AREA TOPOGRAPHICAL SURVEY		
PROPOSED CONVOCATION CENTER ARKANSAS STATE UNIVERSITY ONESBORO, ARK.		
PREPARED BY: HAYWOOD KENWARD & ASSOCIATES, INC. CIVIL Engineering & Surveying Jonesboro, Ark.	DATE: 10-83	SCALE: 1"=100'
DRAWN BY: J.K.		1:1

A.S.U. CONVOCATION CENTER

SITE PLAN

7/25/84

QUAD. "D" FOUNDATION PLAN

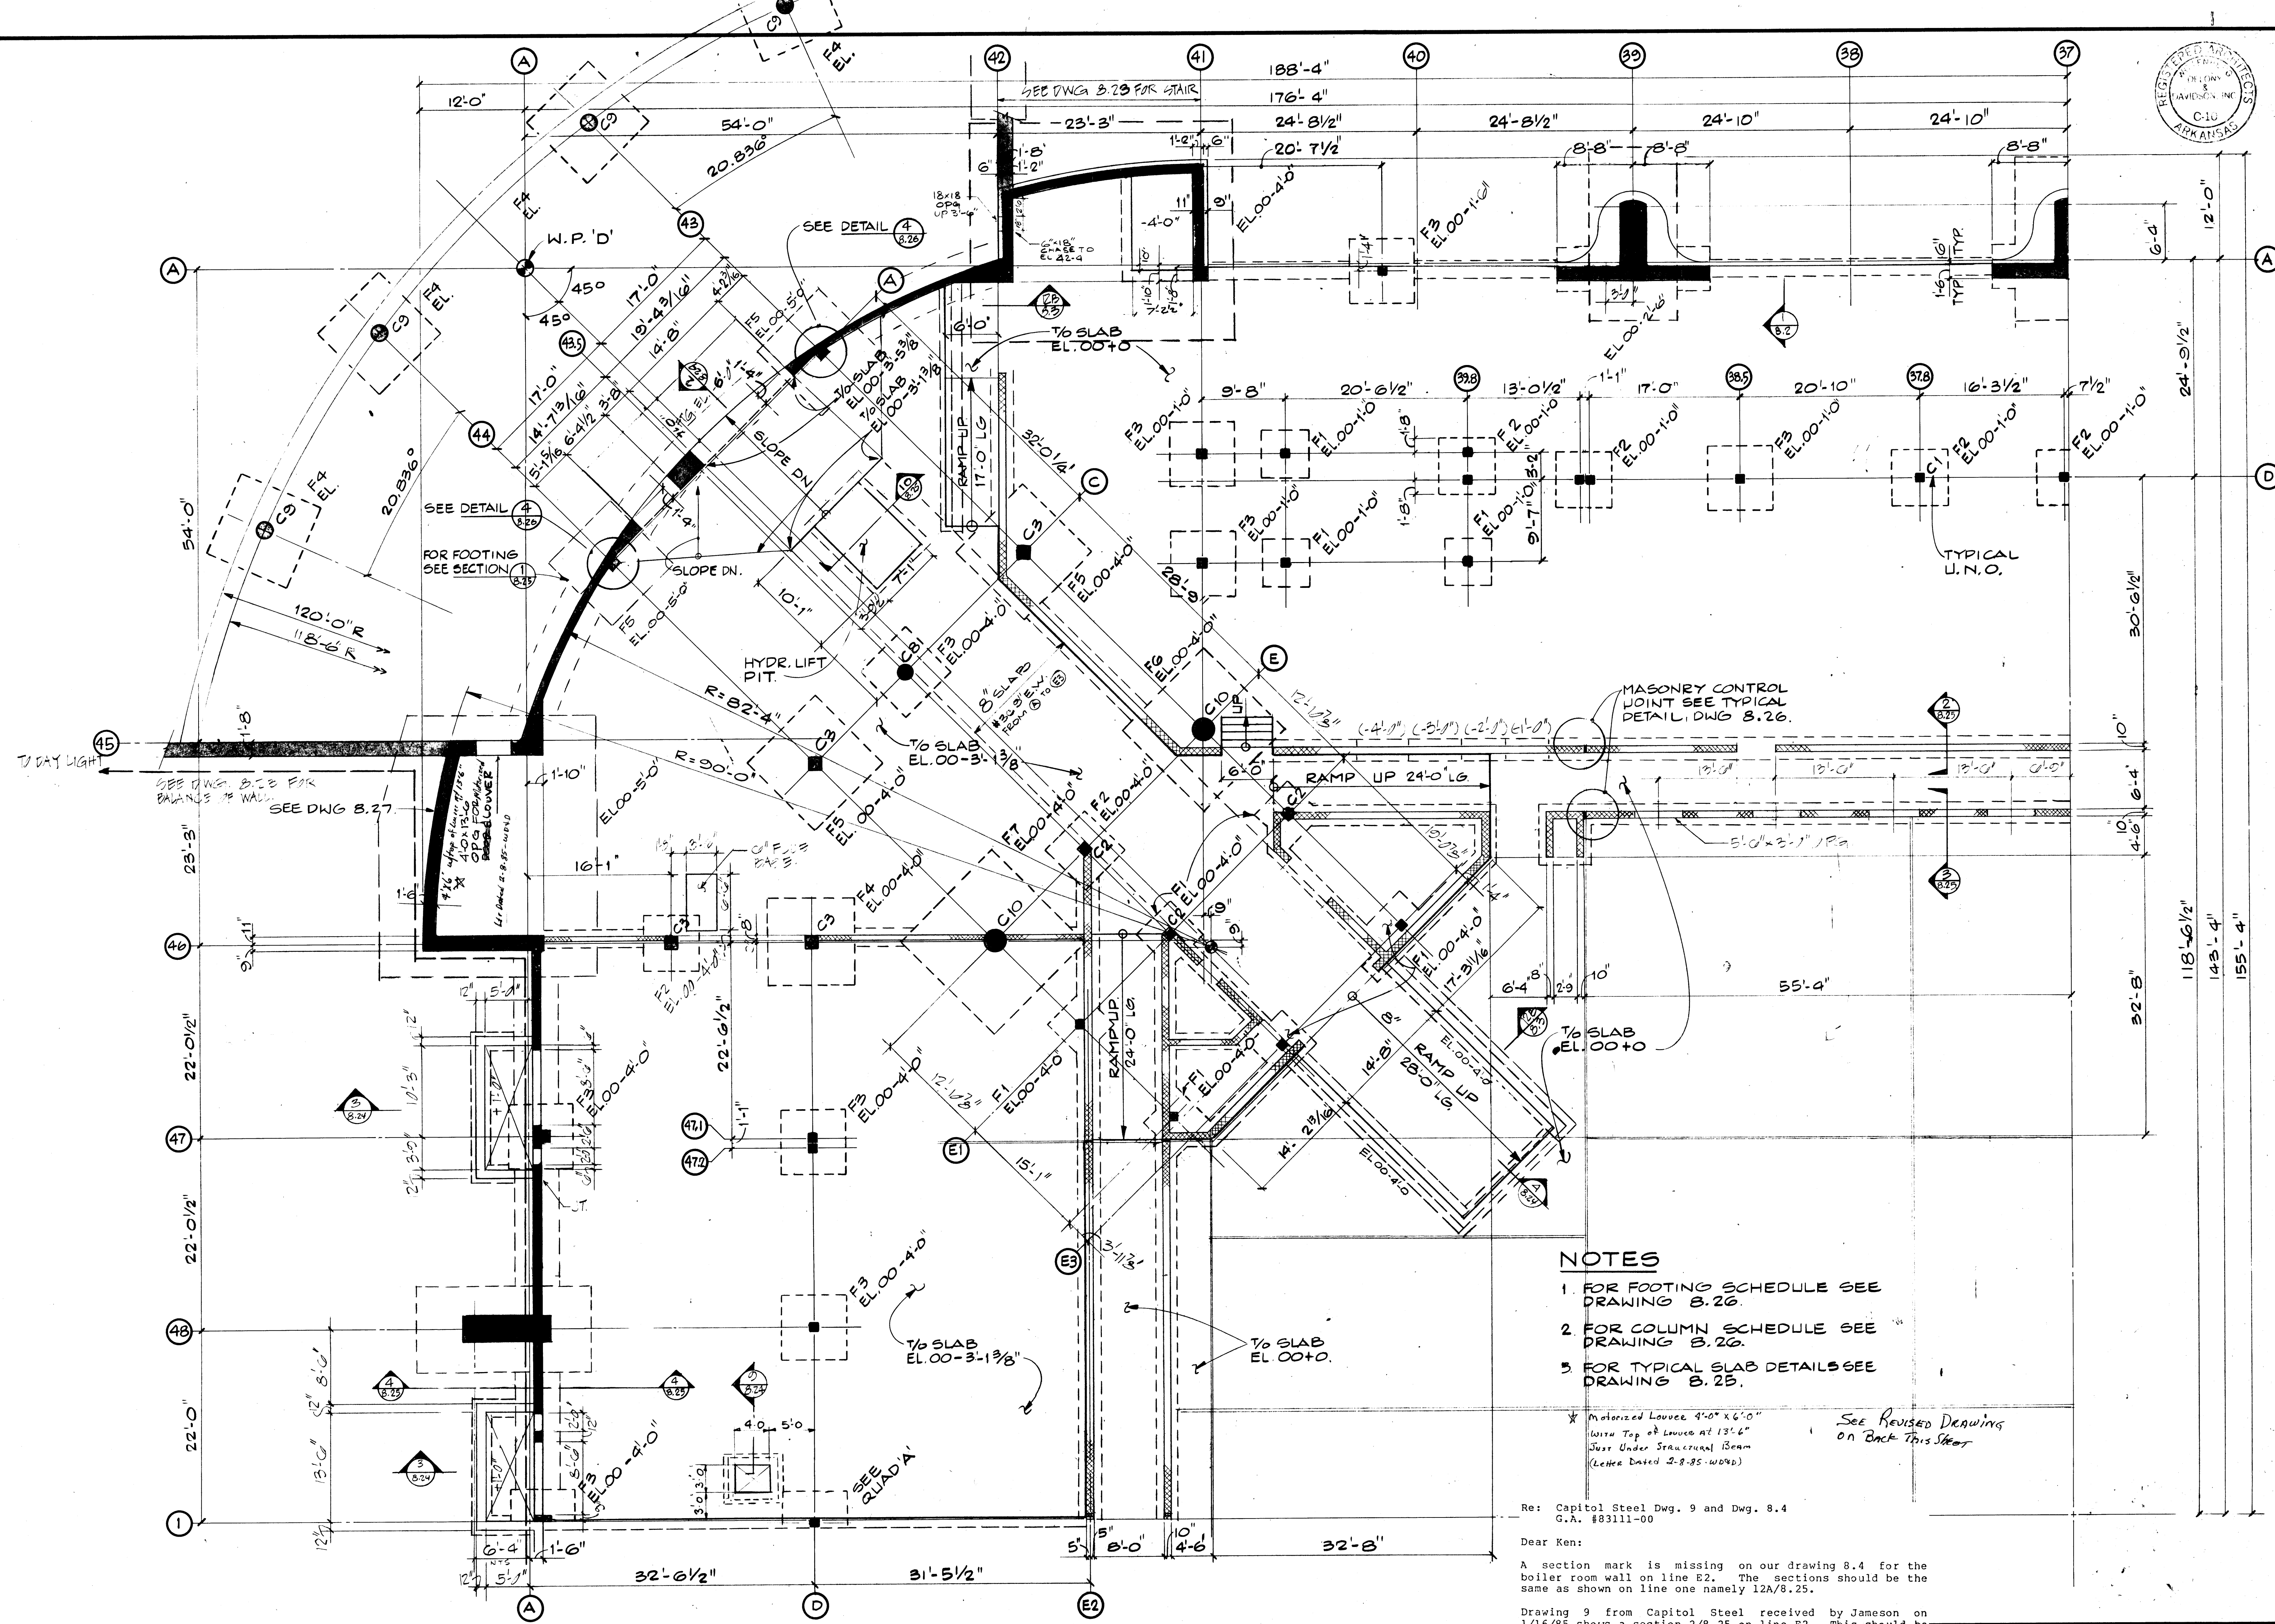
Please refer to drawings 2.5 and 8.2. The north wall of Multi-purpose room 139 shall be a 12" wall as shown on 8.2, not an 8" wall as shown on 2.5. This makes the dimension across Dishwashing 141 15'-1" instead of 15'-6".

Drawings 8.2 and 8.3 are being revised by Mr. Neal Schlendorf in the same area as mentioned above to reflect the correct wall locations. As soon as we receive it we will forward it to you.

SECTION 3
 3/8

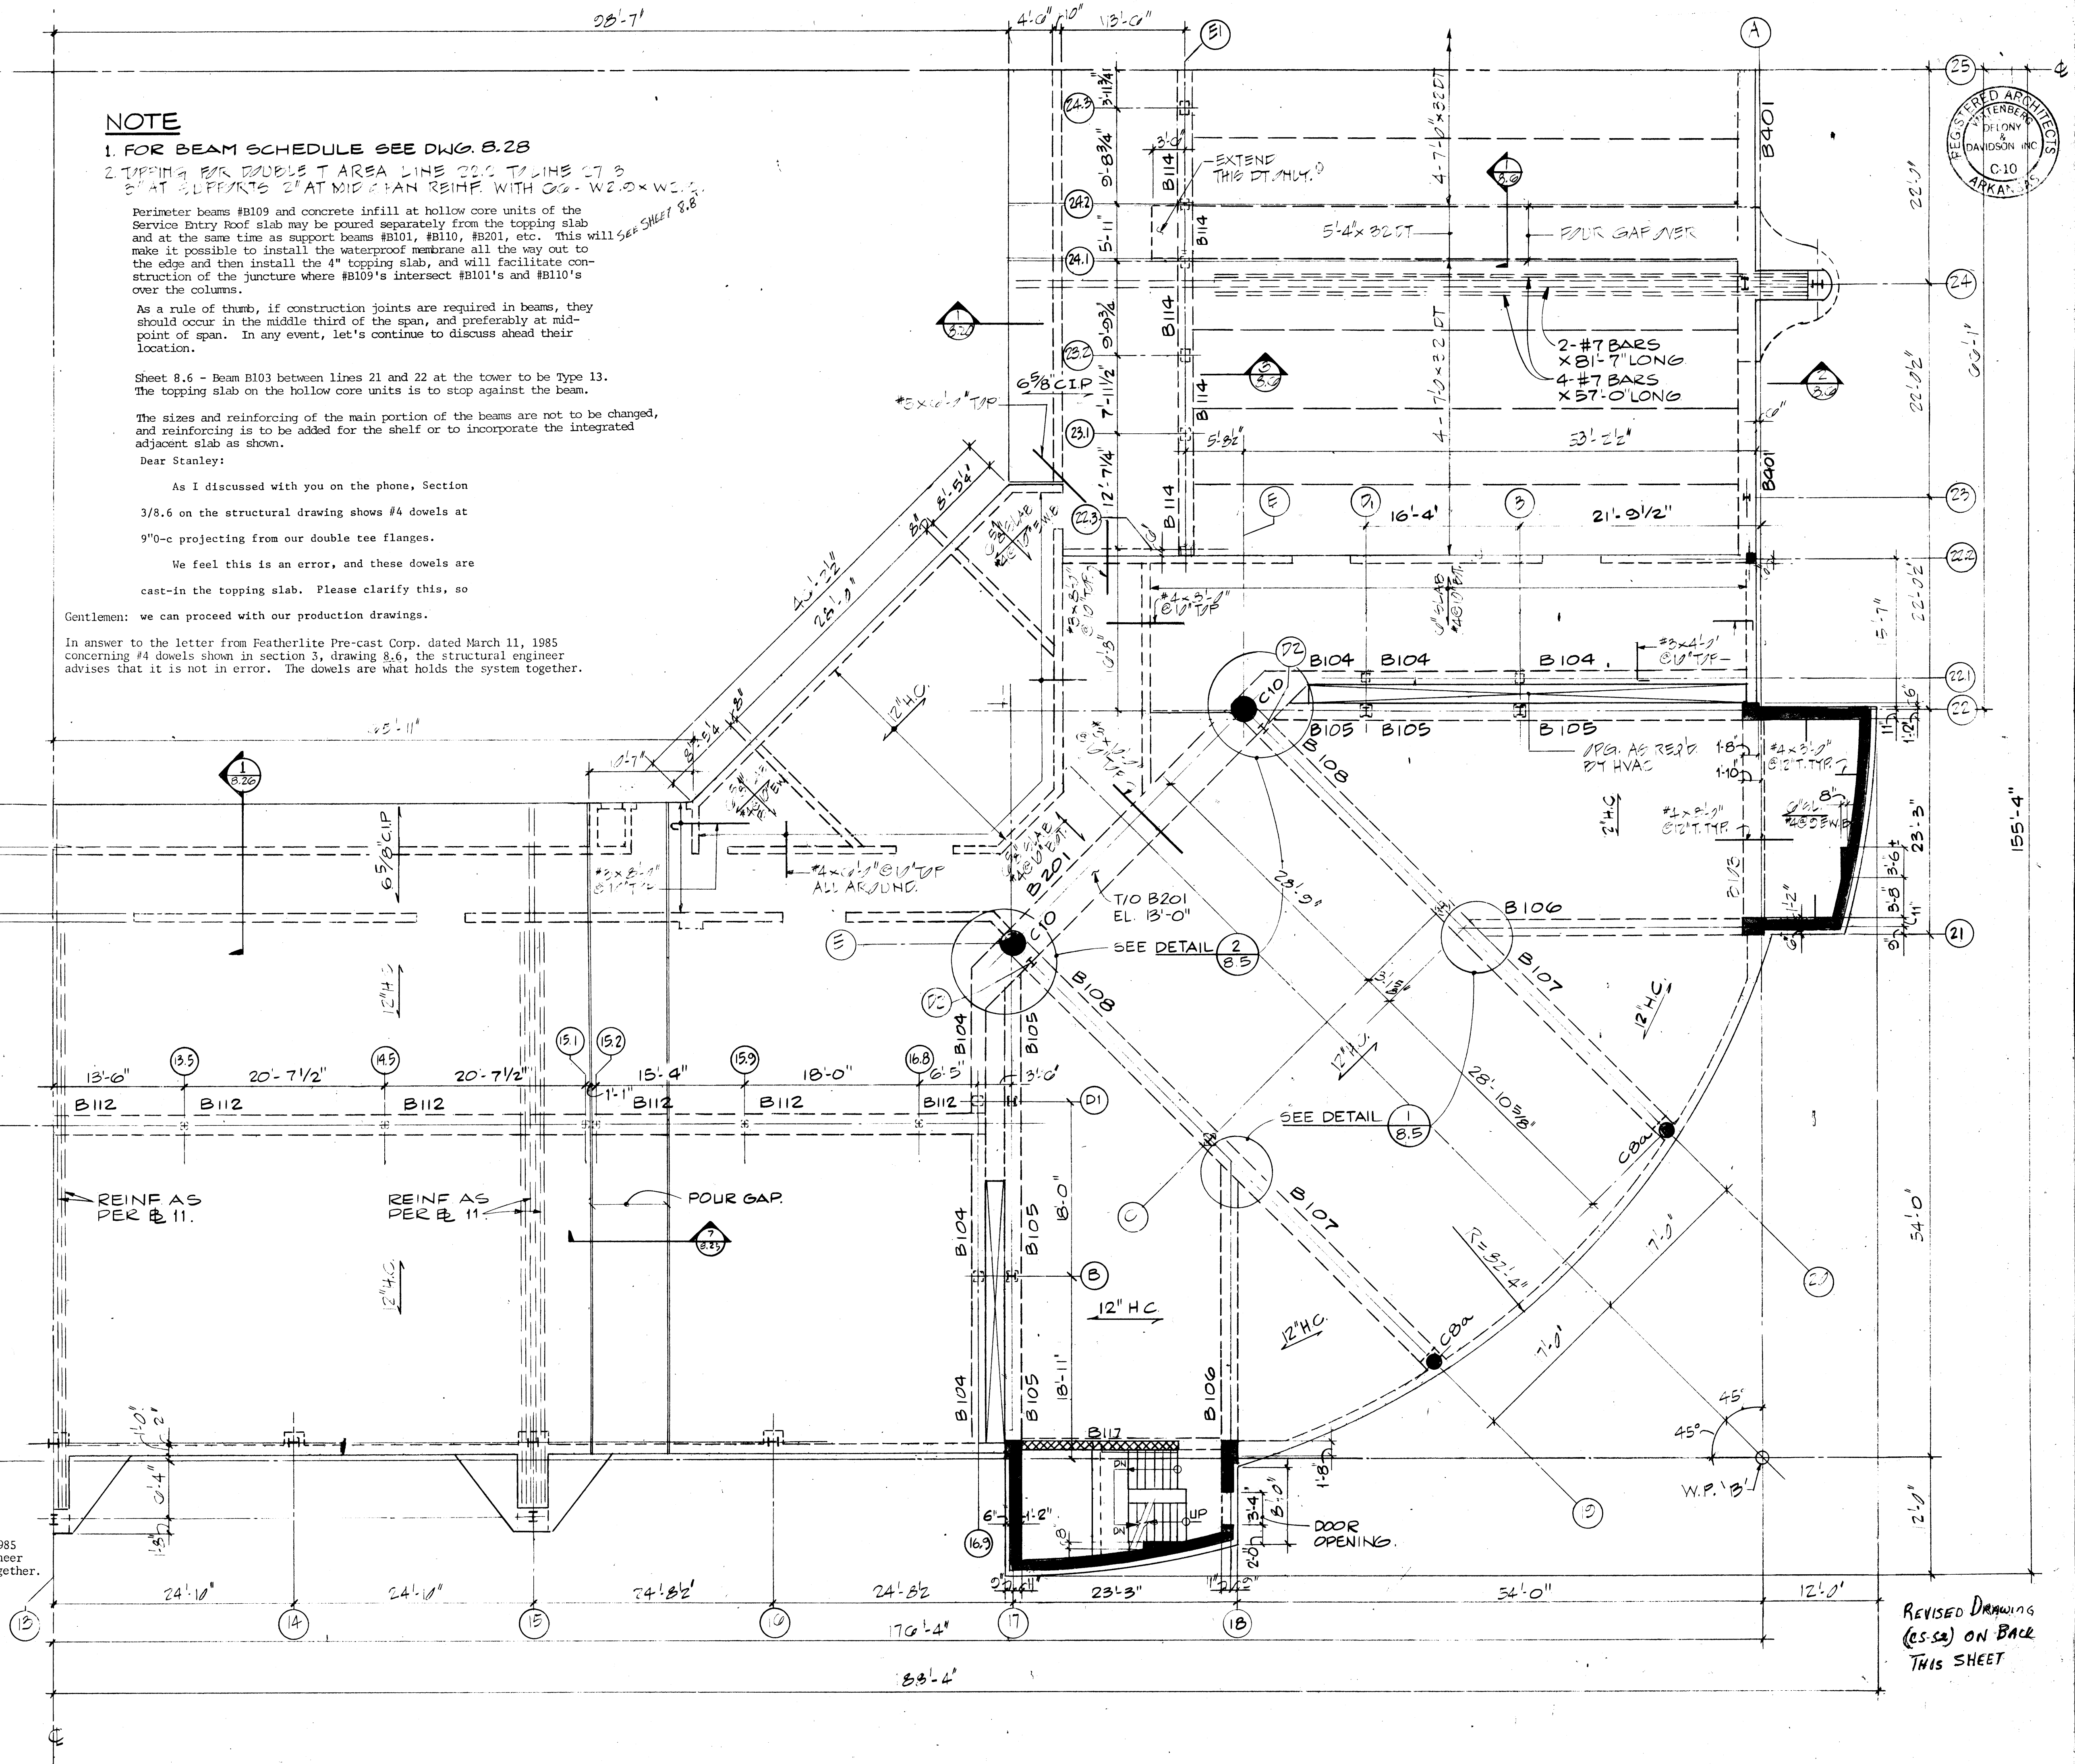
As I discussed with you on the phone, Section 3/8.6 on the structural drawing shows #4 dowels at 9"0-c projecting from our double tee flanges.

We feel this is an error, and these dowels are cast-in the topping slab. Please clarify this, so

In answer to the letter from Featherlite Pre-cast Corp. dated March 11, 1985 concerning #4 dowels shown in section 3, drawing 8.6, the structural engineer advises that it is not in error. The dowels are what holds the system together.

In answer to the letter from Featherlite Pre-cast Corp. dated March 11, 1985 concerning #4 dowels shown in section 3, drawing 8.6, the structural engineer advises that it is not in error. The dowels are what holds the system together.
